Petition Number: 2021-101 General Location Identifier: 19934202

Revision Log:

Date	Description	
08-20-2021	First Review (KP)	
02-23-2023	Second Review (PDM)

General Review Information

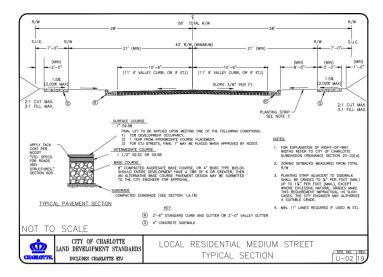
3. **OUTSTANDING COMMENT FROM 08-20-21:** Revise the site plan and conditional notes to commit to coordinate with the property owners, along the private segment of Rainbarrel Road, to provide suitable and feasible traffic calming measures along this private segment of Rainbarrel Road.

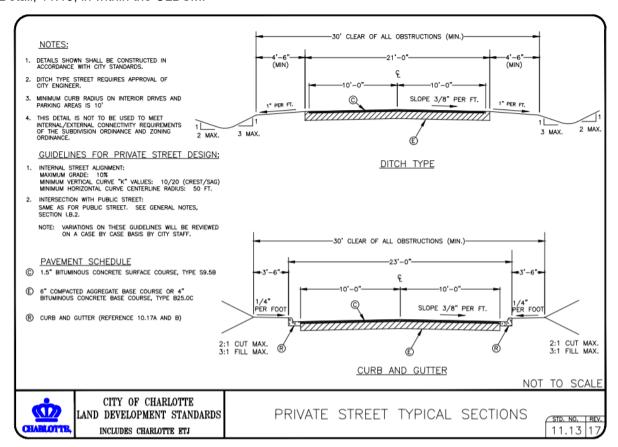
4. **OUTSTANDING COMMENT FROM 08-20-21:** Revise the site plan and conditional notes to commit to improve the public portion of Rainbarrel Road to City Standards in accordance with the CLDSM USDG U-02, Local Residential Medium, cross section.

OUTSTANDING COMMENT FROM 08-20-21: Revise the site plan and conditional notes to commit to improve the private portion of Rainbarrel Road in accordance with the Typical Private Street Section Detail, 11.13, in within the CLDSM.
